DESIGN REVIEW COMMITTEE

February 21, 2024 6:00 PM

DEPARTMENT OF PLANNING AND ZONING
PLANNER'S REPORT

DATE:	February 15, 2024	Key:	
TO:	Tonya Hutson	Compliant:	✓
FROM:	Lynn Patterson	Not Compliant:	✗
RE:	Design Review – 551 Lake Drive – Addition and Front Remodel	Incomplete:	✋
		Not Applicable:	⊘

1
B1.0

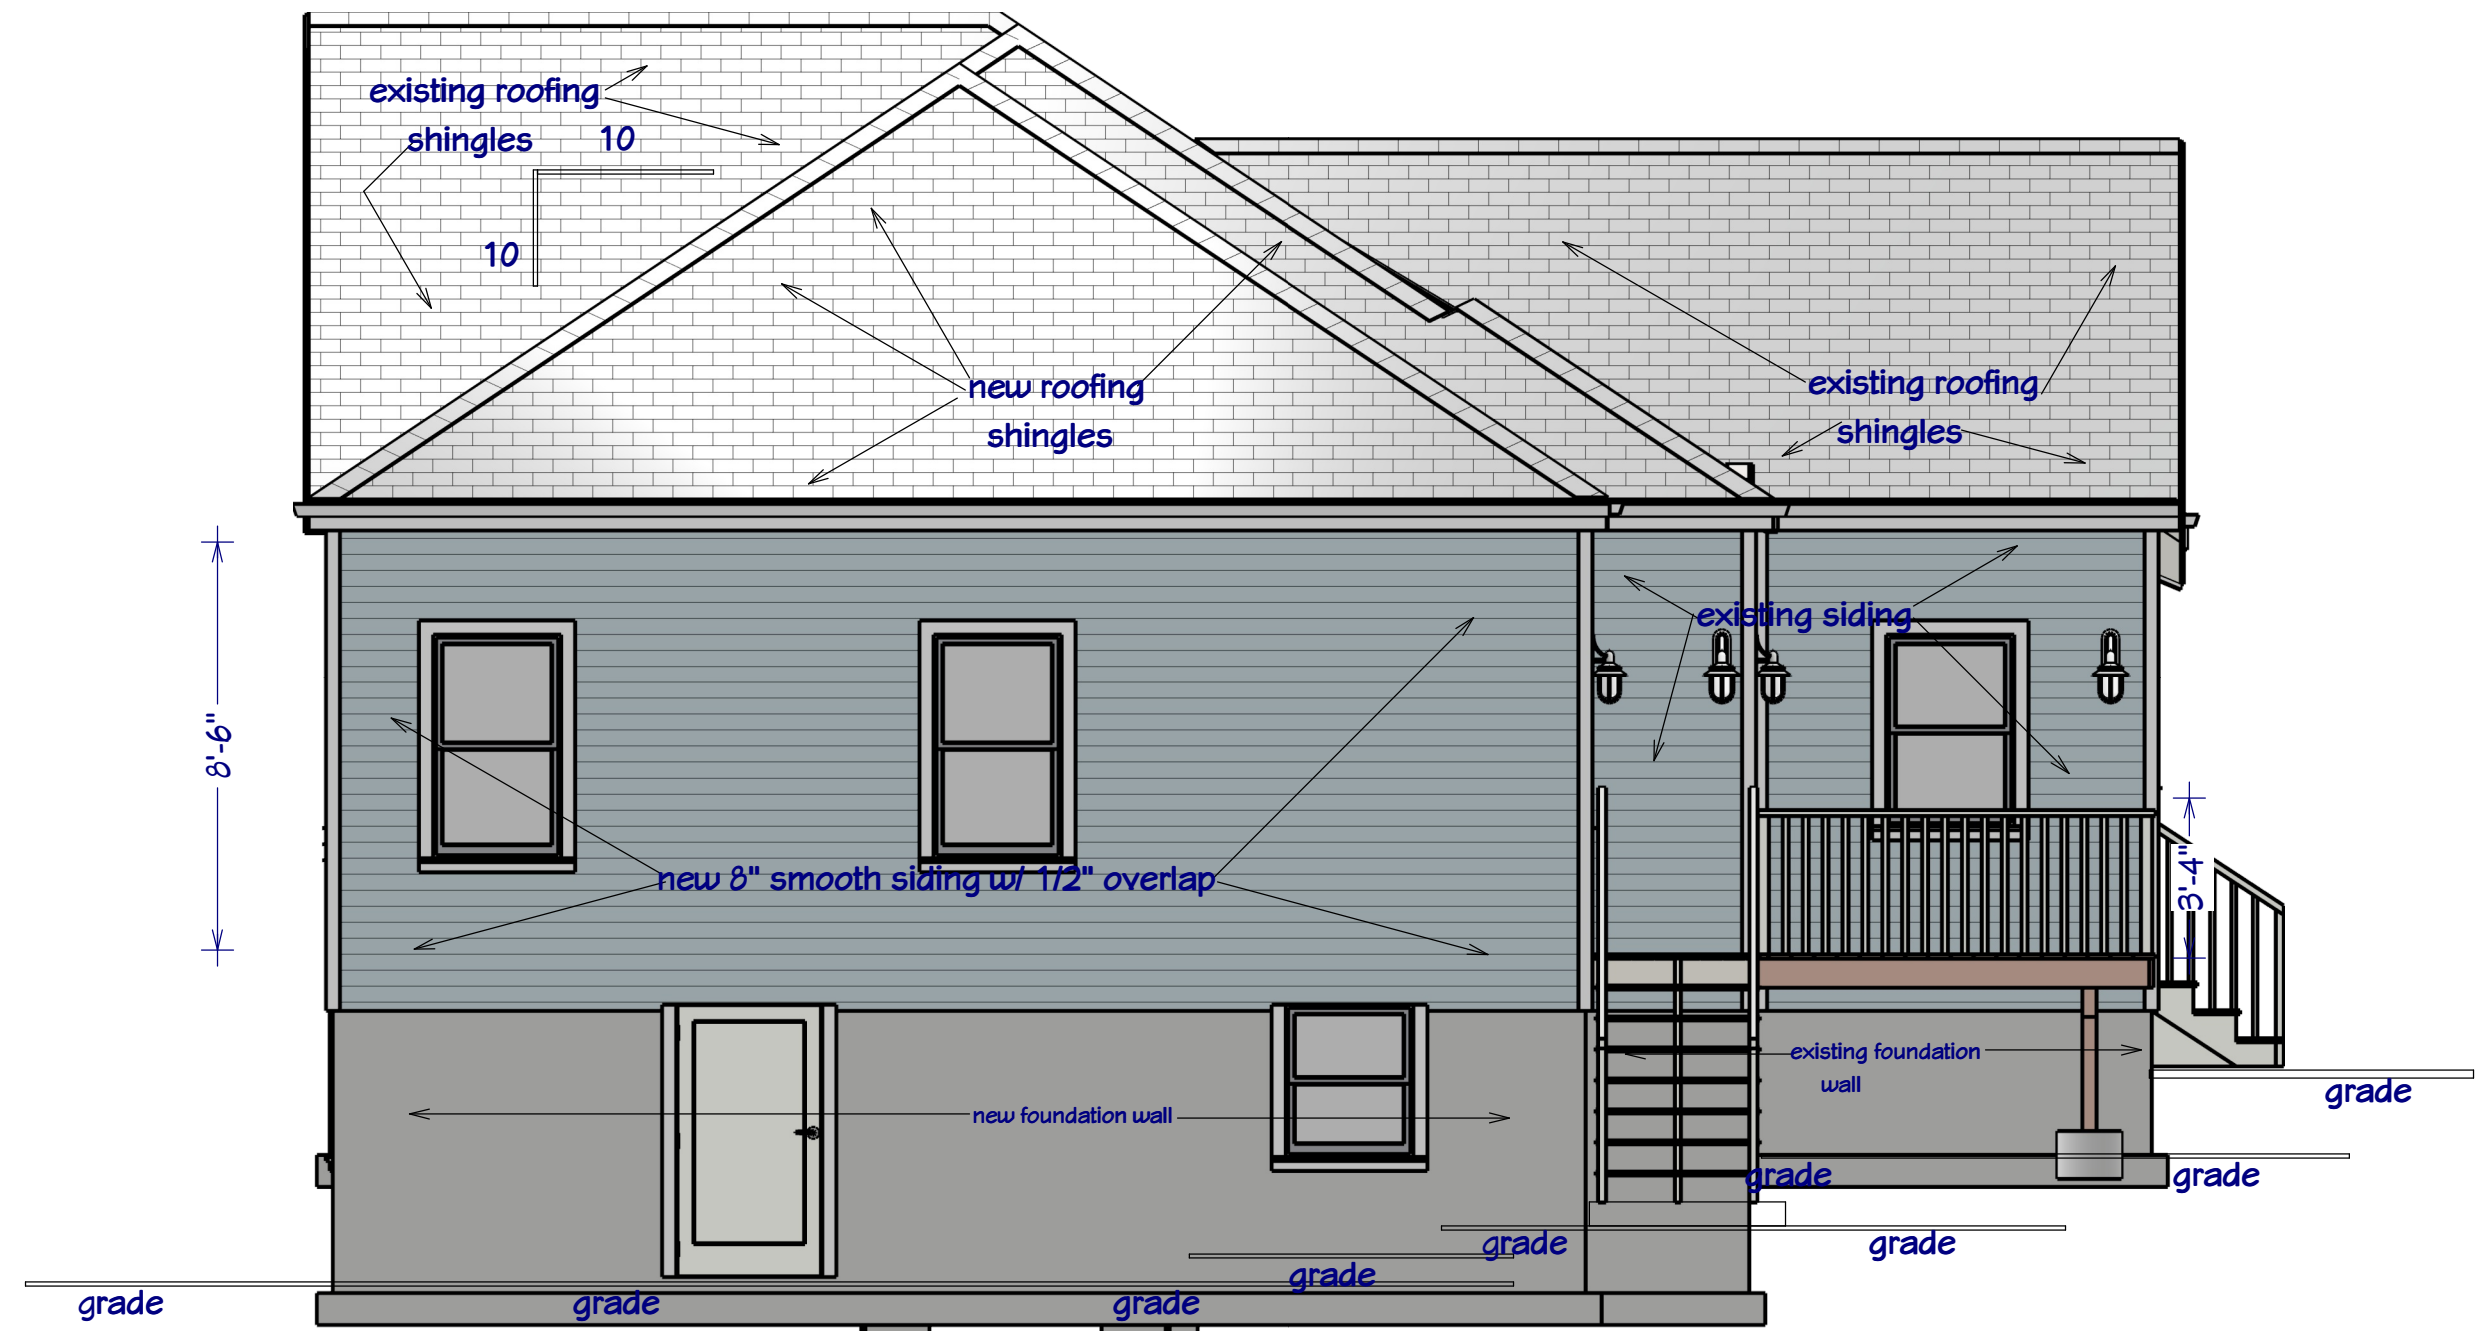
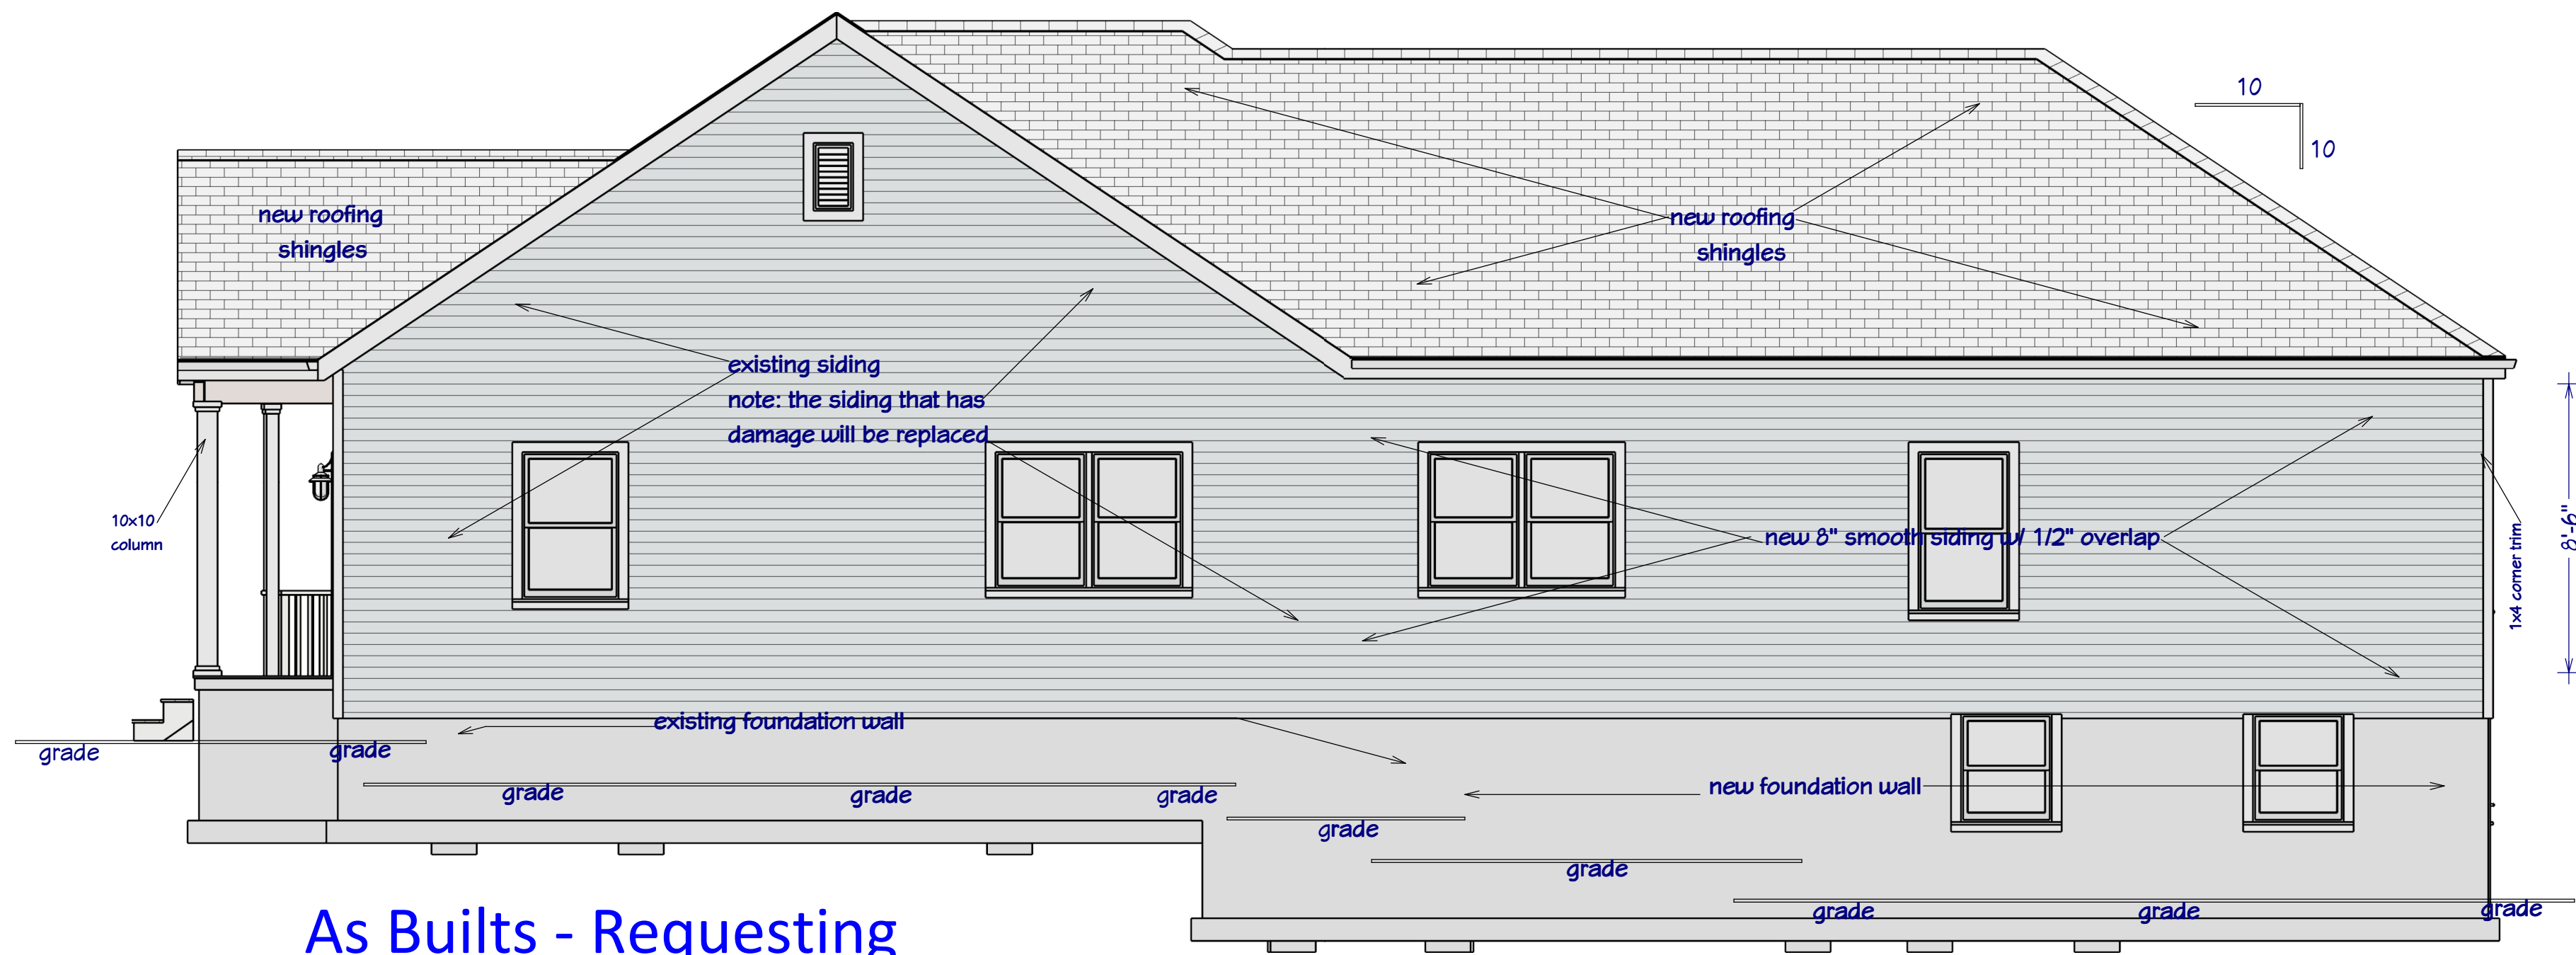
Roofline: The front roof line was changed to have a gabled front over the main entry area and a hip roof over the side porch entry. The left side elevation changed slightly. The roofline on the back hip section still has the dip as show on page 11 of the plans.

Front Porch: The front porches were connected as previously approved by DRC and columns were added, however, one column's spacing does not meet City's maximum spacing of 8'. It is approximately 10' on center. The double columns have been replaced with single columns including a middle column, which had been approved but was not centered under gable. No railing is shown.

Porches are joined

Roofline: Front roof line was changed. A gabled front over the main entry area and a hip roof over the side porch entry. The left side elevation changed slightly. The roofline on the back hip section still has the dip as show on page 11 of this document. Requesting approval of rooflines and roof architecture as built on site.

Front Porch: front porches were connected as previously approved by DRC. Columns have been added, but one column space does not meet cities maximum spacing of 8'. Column to column is approx. 10' Requesting approval of 10' column spacing. Stair to front entry has not been built. Stair will be centered on doorway.

As Built Front Elevation Unit 14 1/4" = 1'-0"

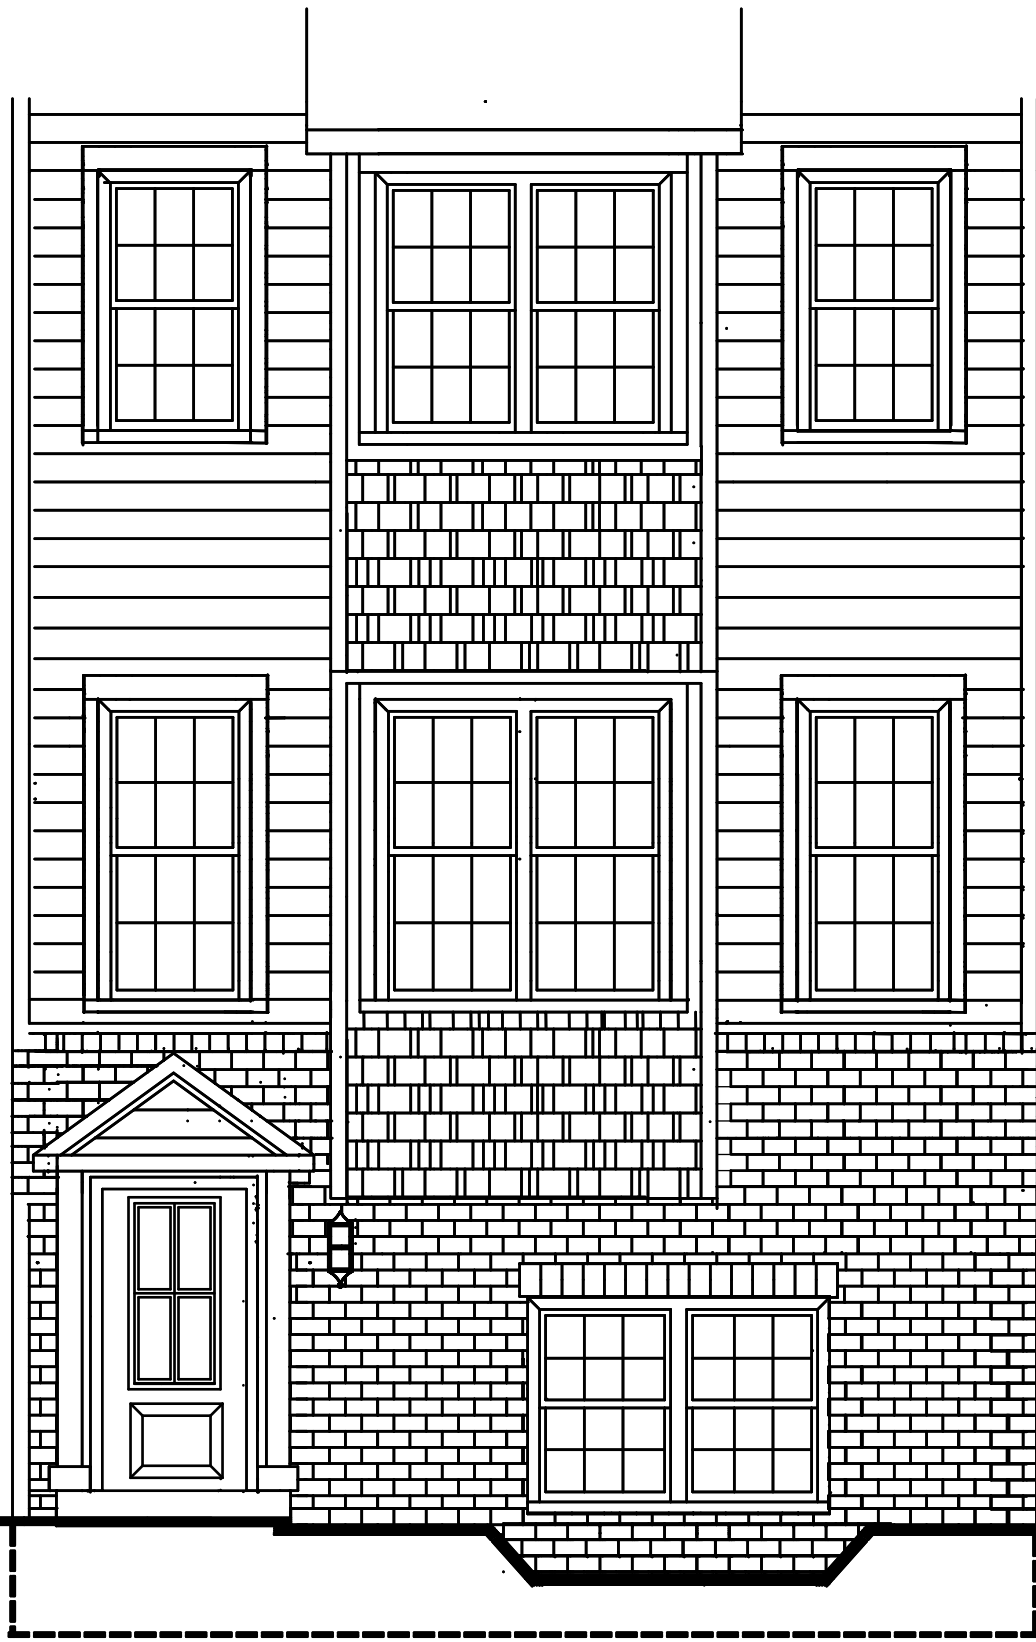
- **The as-built still does not show the proper side elevation for units 11 and 14.**
- **Shake siding has been added to Units 11 and 14; there is no detail for the sides of the bumpout / cantilever portion.**
- **The as-built rear garage door elevation shows windows in the garage doors. No windows are present in the garage doors as installed.**
- **The pediments shown on the as-built are not as constructed and the proposed pediments are not similar to the approved elevations.**

Proposed Sloped Soffit 1" = 1'-0"

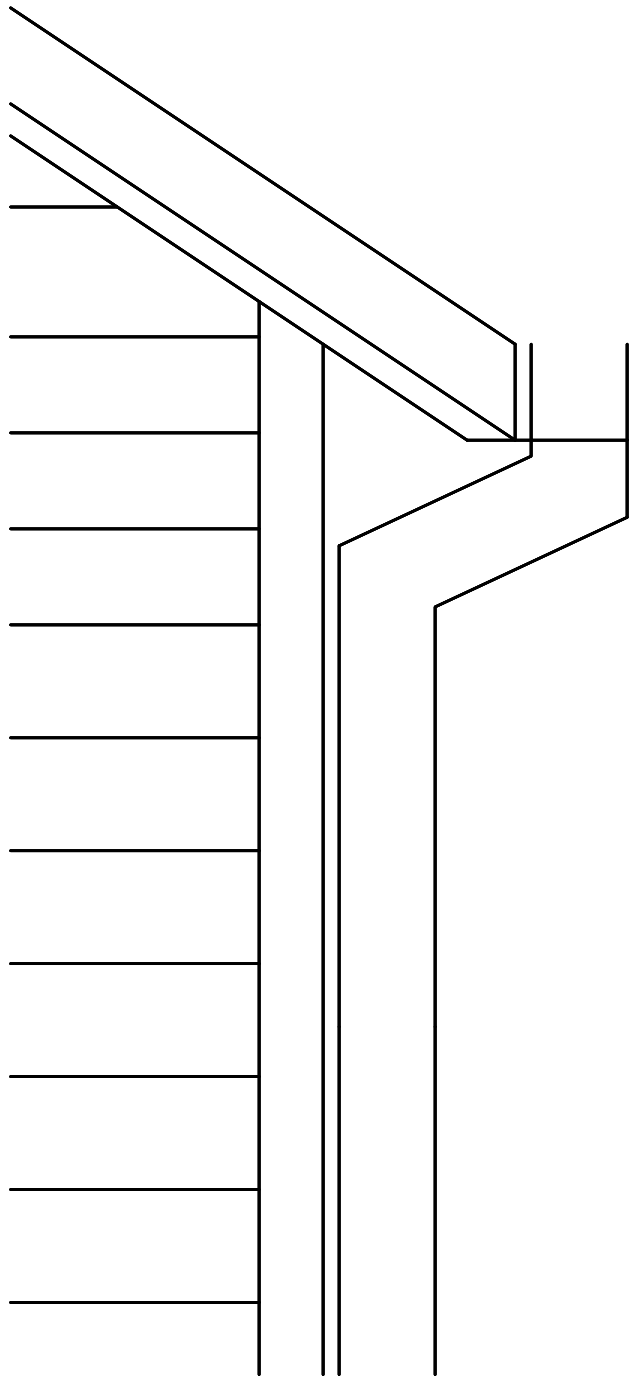
- 7: Change installed bird box soffits to sloped soffits
- 8 - Unit 11: Bottom of the eave/slope of the roof will be 6-inches above the trim
- 9 - Unit 14: Add shake siding to all three sides of the center mass/bay window tower
